Re: Sauer Dump Superfund Site Administrative Settlement Agreement and Order on Consent for Remedial Investigation/Feasibility Study (ASAOC) dated March 11, 2013 Docket No. CERC-03-2012-0177DC

EPA Comments to RI/HHRA/ERA 11/25/2019

Revised Remedial Investigation Report, Sauer Dump Superfund Site, September 2019

Subject: Sauer Dump Superfund Site Review of PRP's Revised Remedial Investigation Report and Human Health Risk Assessment, dated September 2019 EPA Contract EP-S3-07-05, Work Assignment 055RIFS03EW

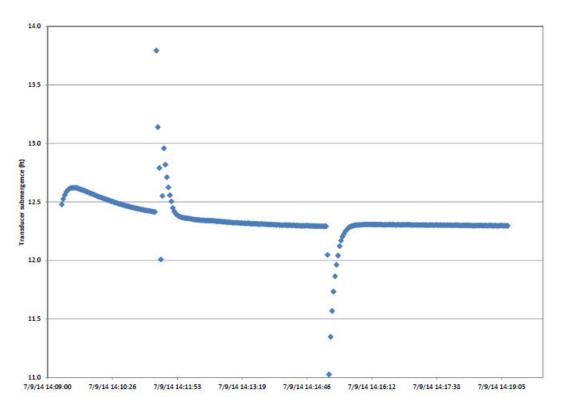
A cursory review of the slug test data suggests that the tidal influences might not have affected the results as significantly as proposed. For example, in the slug test analysis presented for MW-1R in the figure below the downward trend for the first few minutes appears to be due to insufficient time for the water-level to equilibrate after the transducer (and cable) was installed. The slug was introduced about 1 minute after the transducer, which is not much time for equilibration. From about 1416 to the end of the test there are clearly no (or minimal) tidal effects. The text in the figure caption states: "The slug out could not be interpreted at all as the water-level was falling at a time that it should be rising." The y-axis title on the figure indicates that the y-axis values are the feet of water above the transducer and not the depth to water. Therefore, at the beginning of

the slug-out test (at 14:14:46) there is 11 ft of water above the transducer and within about the first minute the water table <u>rises</u> to where there is 12.2 ft above the transducer. The shape of this curve is exactly what would be expected.

The water level data above is for the MW-1R slug test. The first deviation is the transducer being installed in the well. The second deviation is the slug-in, and the third, the slug-out. The slug-in data could be interpreted but is biased high. The slug-out could not be interpreted at all as the water level was falling at a time that it should be rising. It is not clear how much of the drop on the graph is related to the transducer and how much may be related to a slow drop in the water level due to a tidal influence.

Please review the slug test data and reinterpret as necessary. If the slug-in tests have not been given sufficient time to equilibrate after the transducer has been installed, then more weight should be placed on the slug-out results. Please integrate the revised results into the mass-flux and velocity calculations.
